## Executive Summary

## 1.0 Response to Submission 1 - Peakedale Neighbours

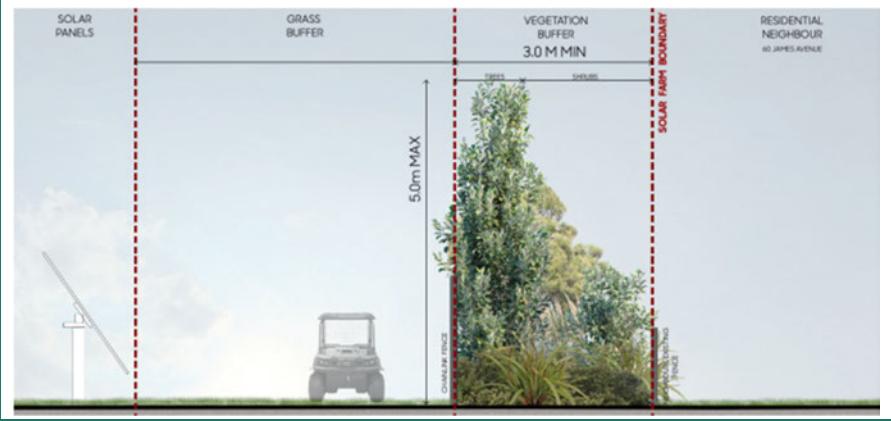
Fails to demonstrate regional or national economic benefits	Please refer to response within Section 17.0 below and the Economic memo included as <b>Attachment 7</b>
Accessways and connectivity – support the removal of pedestrian pathways into Eldonwood, and request condition to ensure this	Pedestrian pathway connections have been removed from the drawing set.
Intend to void the assignment of Founding Member Rights to the developer.	Refer to the Legal Memorandum included as <b>Attachment 1</b> .
Notes similarities between the Ashbourne project and the Delmore project, including highlighting specific provisions of the draft decision	Noted, however not considered relevant to the assessment of Ashbourne.
<p>Whilst the Association re-iterates its opposition to the application, should the Panel choose to approve the Ashbourne Development, the Association would request the following conditions be imposed:</p> <ol style="list-style-type: none"> <li>1. Formal surrender of all rights-of-way and parking easements over Eldonwood's private roads;</li> </ol>	<p>In respect to Eldonwood concerns and specific requests, the developer has the following comments:</p> <ol style="list-style-type: none"> <li>1. Ref: Legal Memo on Surrender of Easements.</li> <li>2. Unity have committed to remove connectivity to Eldonwood. Please refer to update plans.</li> </ol>

<p>2. Removal of all proposed connectivity with Eldonwood, with any connectivity whatsoever to only be with the express consent of the Association;</p> <p>3. Surrender of the rights purportedly assigned in the Deed of assignment dated 31 October 2024;</p> <p>4. Prohibition of topsoil or clay storage along Eldonwood boundaries;</p> <p>5. Implementation of a 10 metre wide green buffer zone along all shared boundaries, including:</p> <ul style="list-style-type: none"> <li>• Mature native plantings at 900 mm centres;</li> <li>• 100 mm bark mulch cover;</li> <li>• Full irrigation system;</li> <li>• Landscape Management Plan outlining maintenance obligations in perpetuity for the buffer zone; and</li> <li>• Consent notices registered on Ashbourne titles confirming these obligations.</li> </ul> <p>6. The provision of comprehensive hydrological studies evidence/data and detailed mitigation measures to address flooding and groundwater development impacts for surrounding properties, including Eldonwood.</p> <p>7. Independent peer reviews of all technical reports, including stormwater, wastewater and geotechnical assessments.</p>	<p>3. Ref: Legal response to Surrender Deed of Assignment Rights. Unity uphold the DoA. This is a private deed is between Eldonwood Limited and the developer.</p> <p>4. Refer Maven Plans/Management Plan.</p> <p>5. Ref: Greenwoods Landscape Buffer. Unity will be implementing a 2m boundary buffer planting along the full contiguous length of the Eldonwood properties. This will be planted in the planting season following earthworks. Refer Greenwoods Landscape plans for details. A consent notice to be placed on adjacent titles to ensure this is maintained.</p> <p>6. Updated responses have been provided on Hydrogeological matters (<a href="#">Attachment 5</a>) and Engineering (<a href="#">Attachments 9-14</a>)</p> <p>Unity undertook engagement with Joanne Morgan, on behalf of the Eldonwood Residents Association. Joanne is the chair of the Eldonwood Residents Association, and Unity were informed via Joanne that she represented the collective landowners within Eldonwood</p>
